SUBJECT: MILLSTONE POWER STATION, UNIT NO. 2 - ISSUANCE OF AMENDMENT  
RE: TECHNICAL SPECIFICATION CHANGES FOR SPENT FUEL STORAGE  
(TAC NO. MF0435)

Amendment No. 327  
Renewed License No. DPR-65

ATTACHMENT TO LICENSE AMENDMENT NO. 327

FIGURE 3.9-1A MINIMUM REQUIRED AVERAGE FUEL ASSEMBLY BURNUP AS A FUNCTION OF INITIAL ENRICHMENT TO PERMIT STORAGE IN REGION 2A

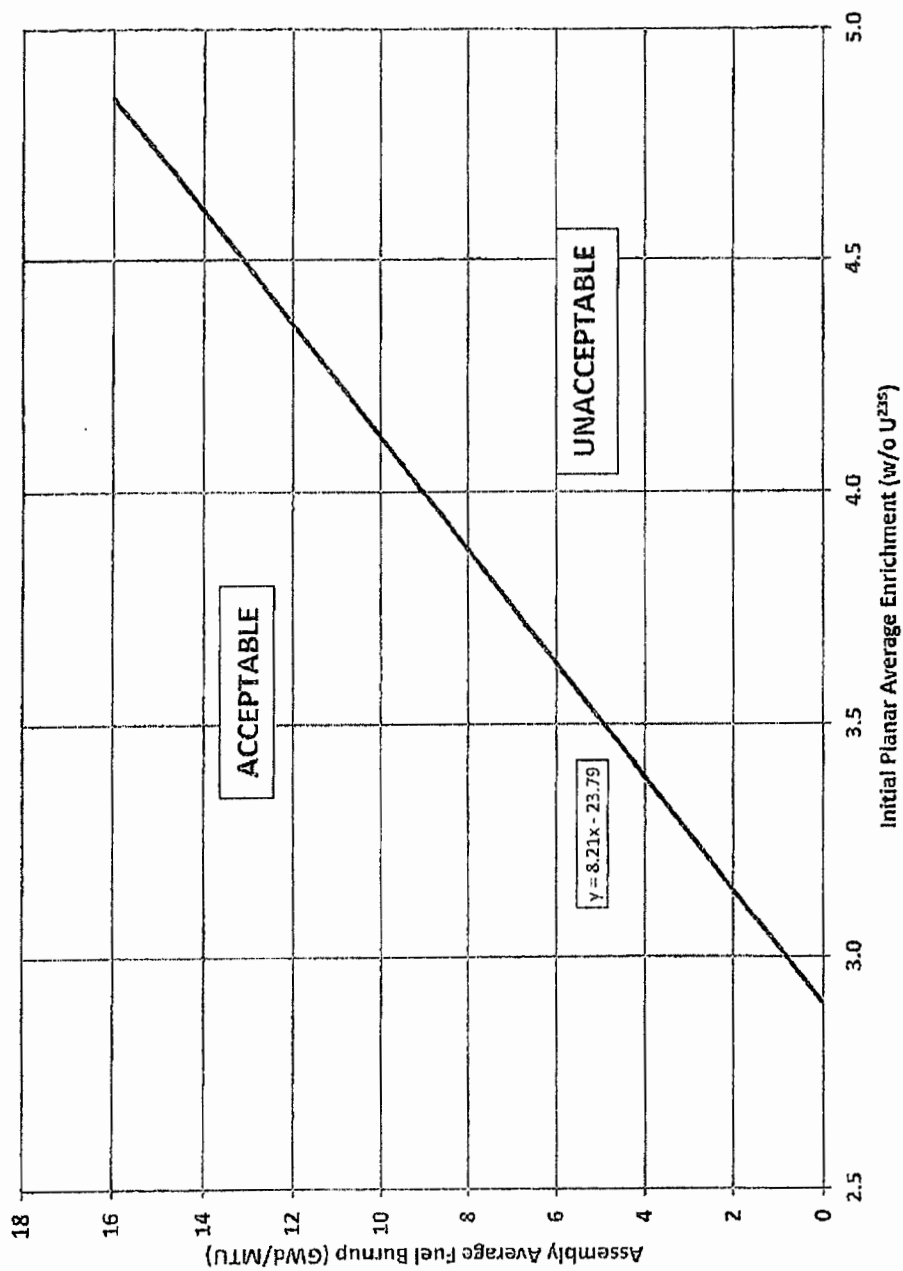
- (b) Region 2 has two types of storage locations:
  - (1) The combination of initial planar average enrichment and burnup of a fuel assembly stored in Region 2 Type 2A shall be within the acceptable burnup domain of Figure 3.9-1A.

FIGURE 3.9-1B MINIMUM REQUIRED AVERAGE FUEL ASSEMBLY BURNUP AS A FUNCTION OF INITIAL ENRICHMENT TO PERMIT STORAGE IN REGION 2B

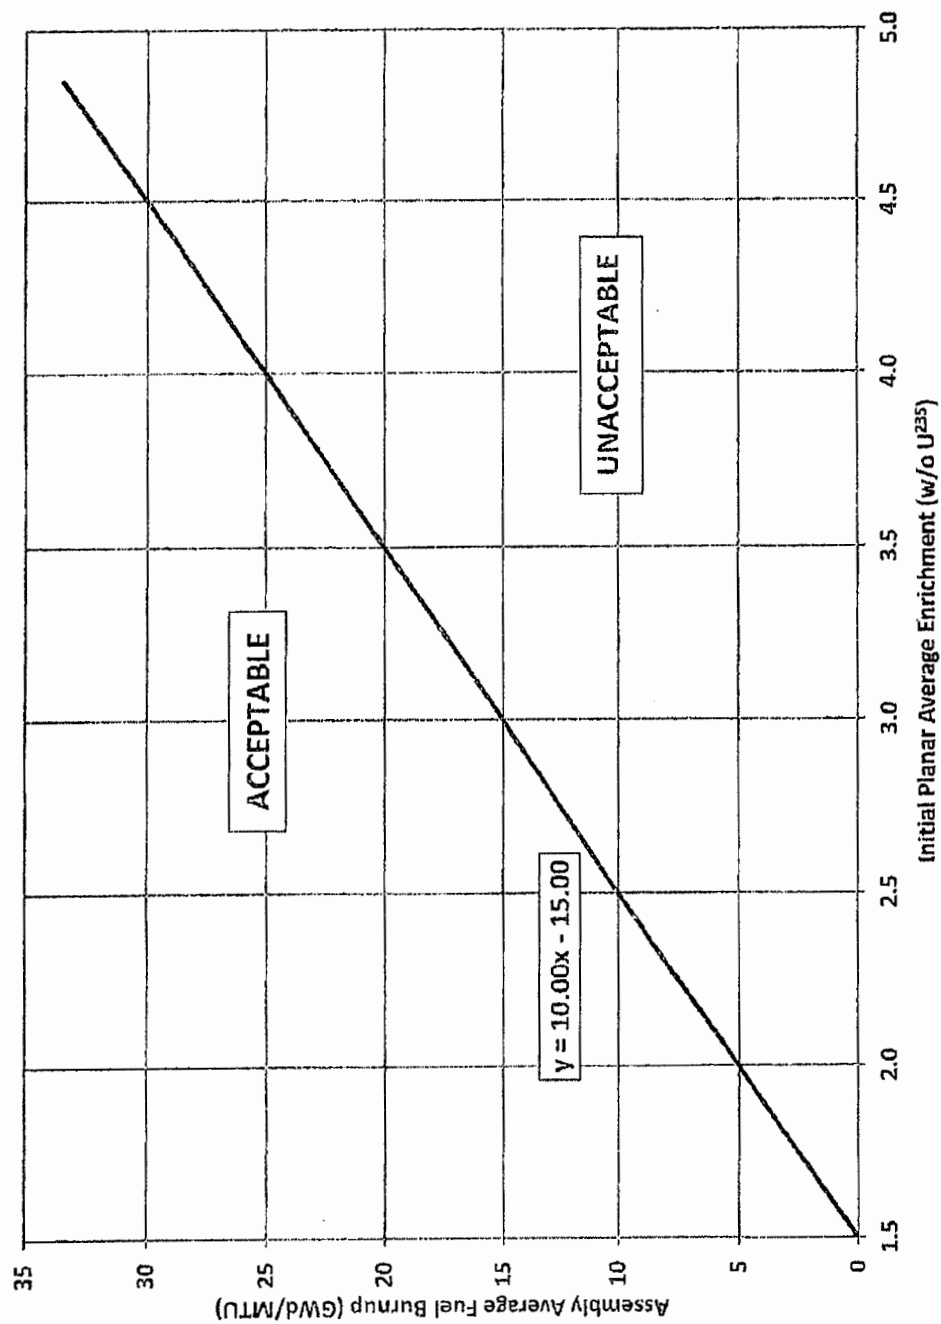
- (2) The combination of initial planar average enrichment and burnup of a fuel assembly stored in Region 2 Type 2B shall be within the acceptable burnup domain of Figure 3.9-1B.

Figure 3.9-1C MINIMUM REQUIRED AVERAGE FUEL ASSEMBLY BURNUP AS A  
FUNCTION OF INITIAL ENRICHMENT TO PERMIT STORAGE IN REGION 3  
(with insertion of 3 Borated Stainless Steel Poison Rodlets)

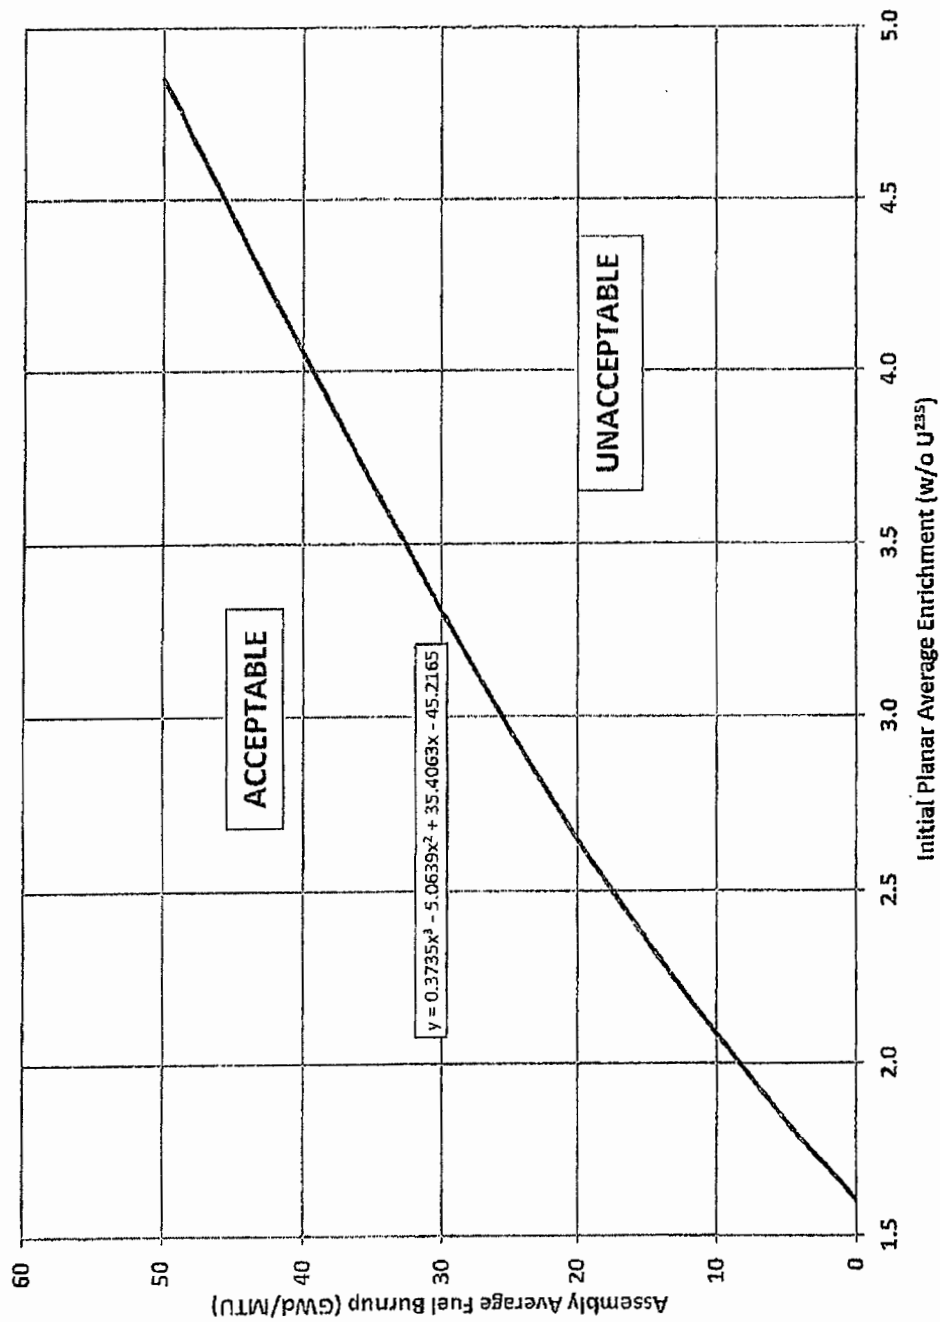
- (1) The combination of initial planar average enrichment and burnup of a fuel assembly containing Borated Stainless Steel Poison Rodlets stored in Region 3 shall be within the acceptable burnup domain of Figure 3.9-1C. The Borated Stainless Steel Poison Rodlets shall be installed in the assembly's center guide tube and in two diagonally opposite guide tubes.

Three rodlets are already inserted into the guide tubes of each fuel assembly stored in Region 3 of the pool and whose enrichment-burnup characteristics conform to the requirements given in Figure 3.9-1C of the modified TS. The rodlets are made of borated stainless steel containing 2 weight percent of boron.

Figure 3.9-1D MINIMUM REQUIRED AVERAGE FUEL ASSEMBLY BURNUP AS A FUNCTION OF INITIAL ENRICHMENT TO PERMIT STORAGE IN REGION 3 (with insertion of a full length, full strength Control Element Assembly)

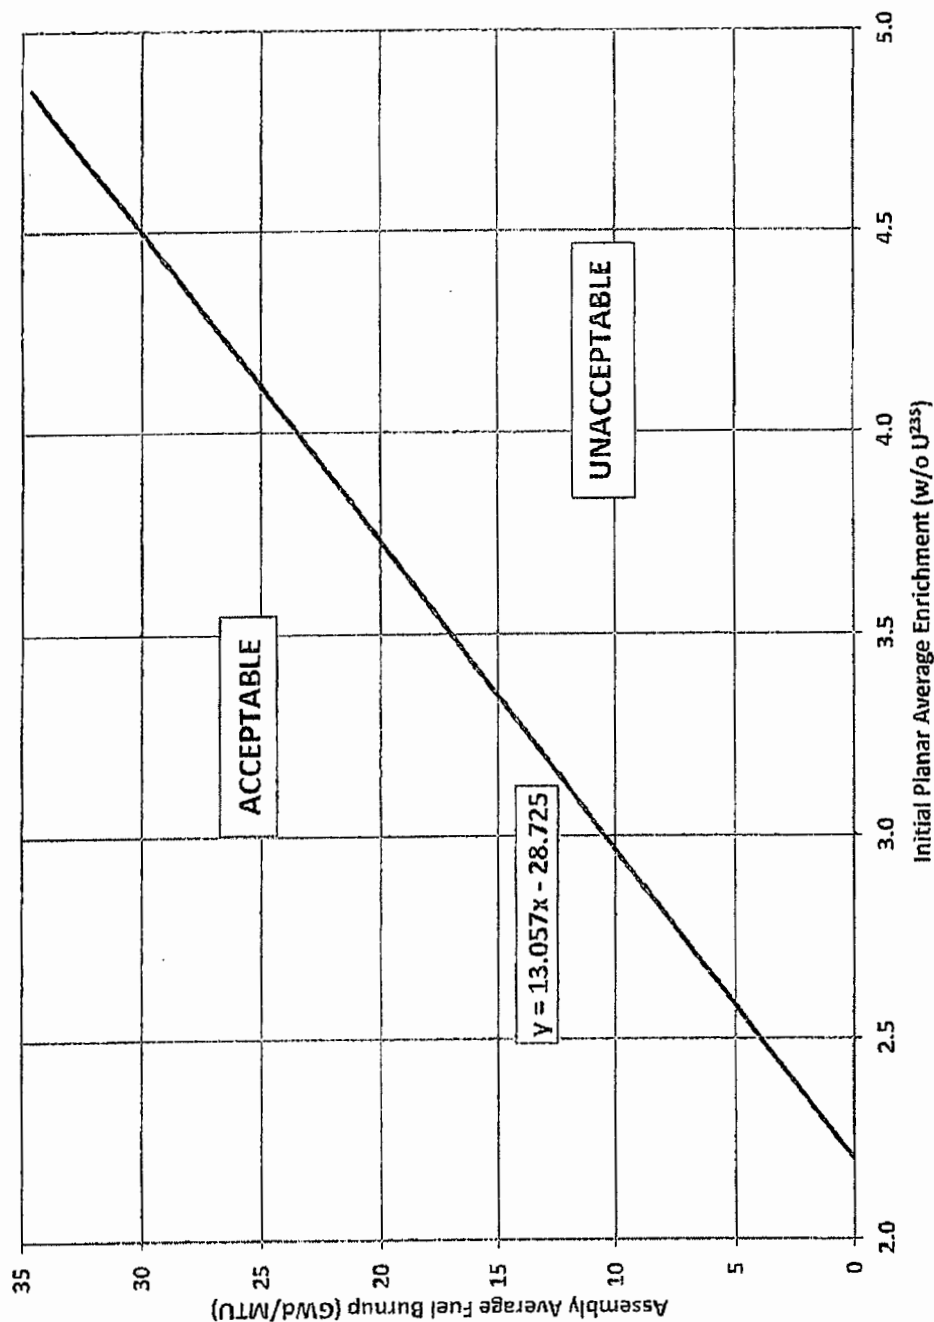
- (2) The combination of initial planar average enrichment and burnup of a fuel assembly containing a full length, full strength Control Element Assembly stored in Region 3 shall be within the acceptable burnup domain of Figure 3.9-1D.\*

FIGURE 3.9-1E MINIMUM REQUIRED AVERAGE FUEL ASSEMBLY BURNUP AS A FUNCTION OF INITIAL ENRICHMENT TO PERMIT STORAGE IN REGION 4

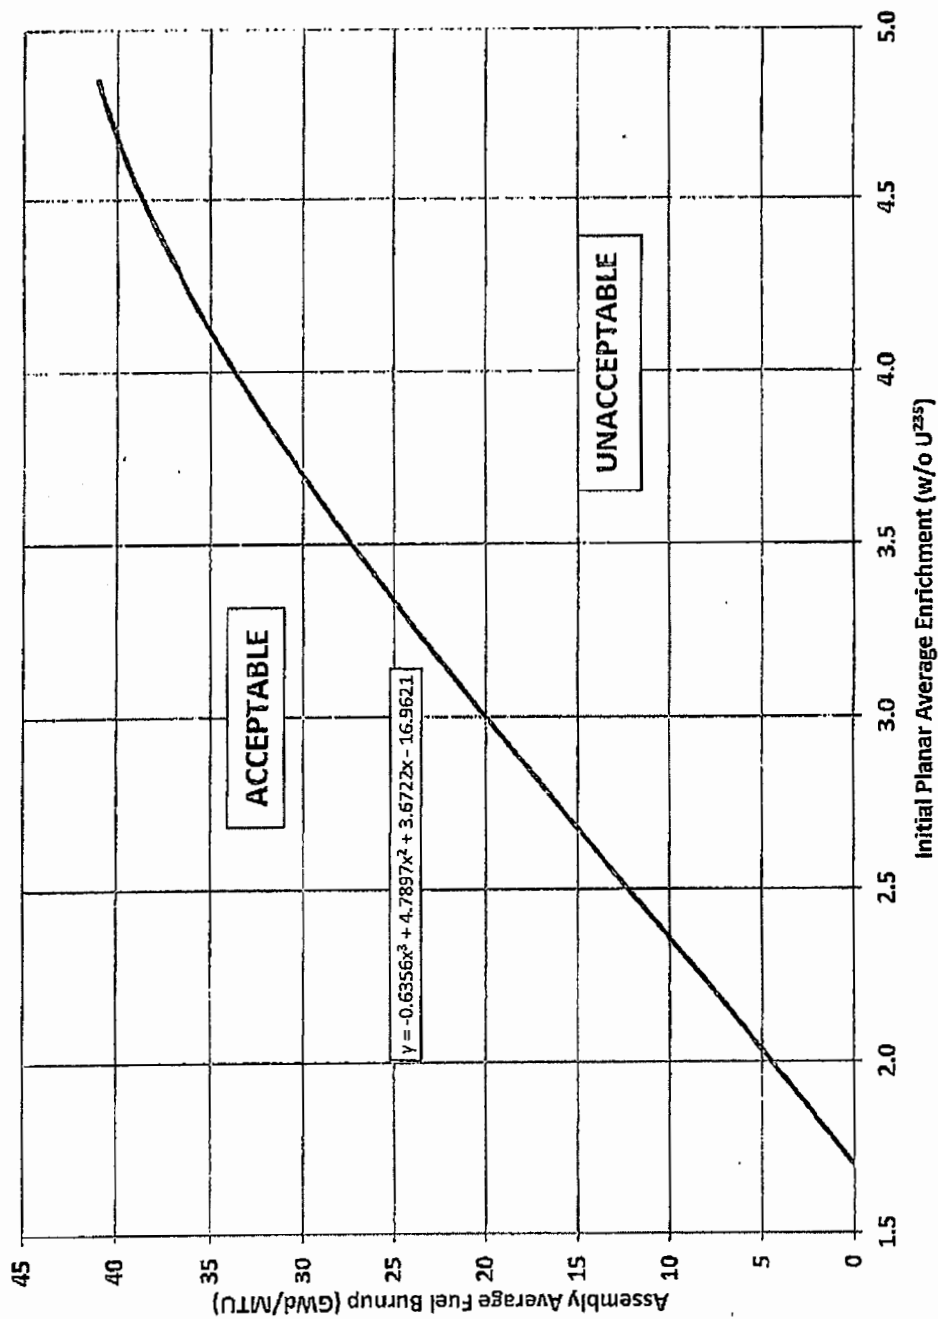
- (d) The combination of initial planar average enrichment and burnup of a fuel assembly stored in Region 4 shall be within the acceptable burnup domain of Figure 3.9-1E.

SPENT FUEL POOL ARRANGEMENT  
FIGURE 3.9-2  
(NOT TO SCALE)

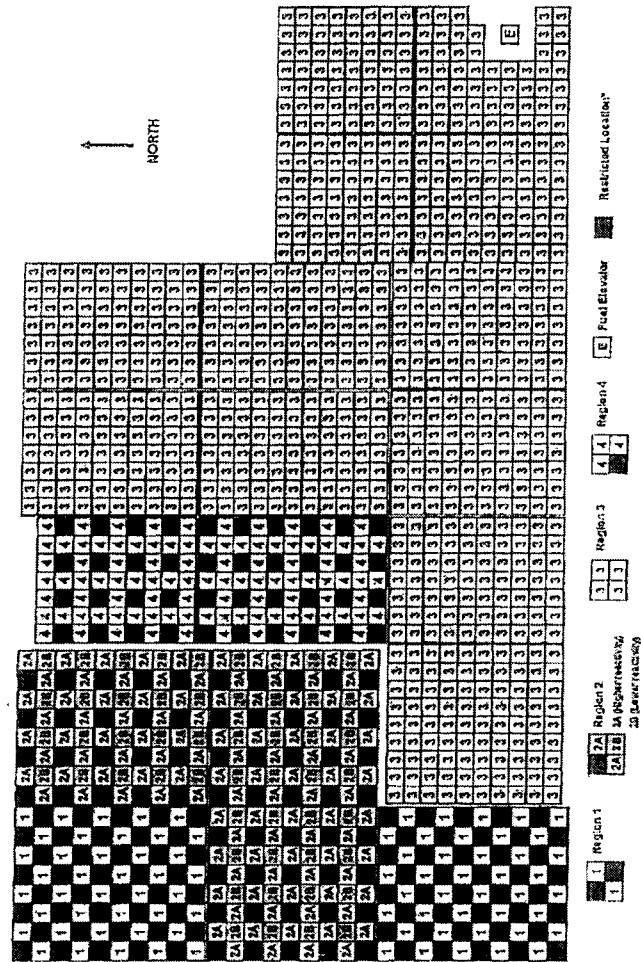
- (1) Restricted Locations shall remain empty. No fuel assembly, no Non-standard Fuel Configuration, no non-fuel component, nor any hardware/material of any kind may be stored in a Restricted Location (shown in Figure 3.9-2).
- (2) Fuel assemblies and Non-standard Fuel Configurations shall NOT be stored in Region 1 and 2 storage locations in which the Boraflex panel box has been removed. It is permissible to store non-fuel components in non-restricted locations with or without a Boraflex panel box. \*

Figure 3.9-2 in the proposed TS provides a graphical representation showing the locations of each region and the required empty or "restricted" locations. As is noted on the figure, storage of fuel or non-fuel components in restricted locations is not permitted.
